Architectural Review Board Report

Architectural Review Board Meeting: August 17, 2020

Subject: 19ARB-0560 to approve the building design, colors, materials, landscape plans, sign plans, and a sign program for a new eight-story (84 feet), 89,593 square-foot, mixed-use building with 140 residential units, ground floor commercial space, and a three-level subterranean parking garage.

Address: 601 Colorado Avenue
Applicant: WNMS Communities

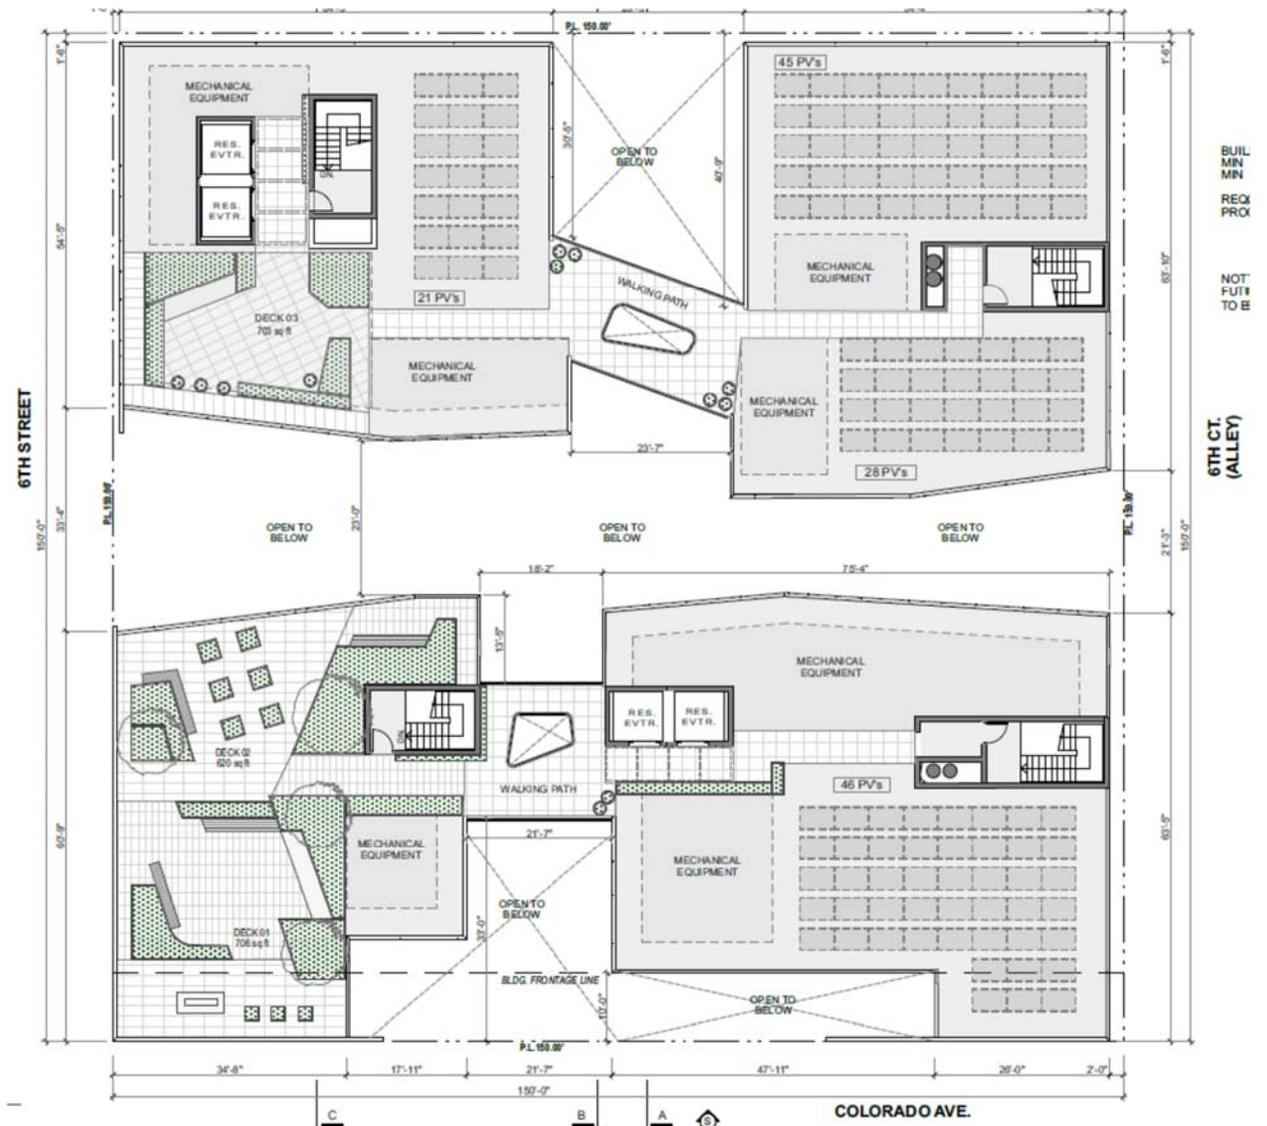
Concern: The landscape design is underwhelming and needs a big design idea. Since the courtyard and plazas are important focal points of the project, the landscape design should be a priority, and the plant palette must be appropriately scaled to the size of the building .

The landscape design offers a counterpoint of curvilinear forms against a rigorously orthogonal building. The design draws inspiration from the coastal bluffs, with a layered approach creating berm-like areas to enable 36” box trees in the podium courtyard.

In order to address the concern of the scale of the proposed plant palette relative to the size and height of the proposed project, the sizes of the prominent tree species have increased in size at the time of installation. The proposed Acacia and Lemon trees will be 24-inch box, while the Gingko, Fruitless Olive, and the American Sumac will be 36-inch boxes. Typically, the larger the box size, the larger the specimen.
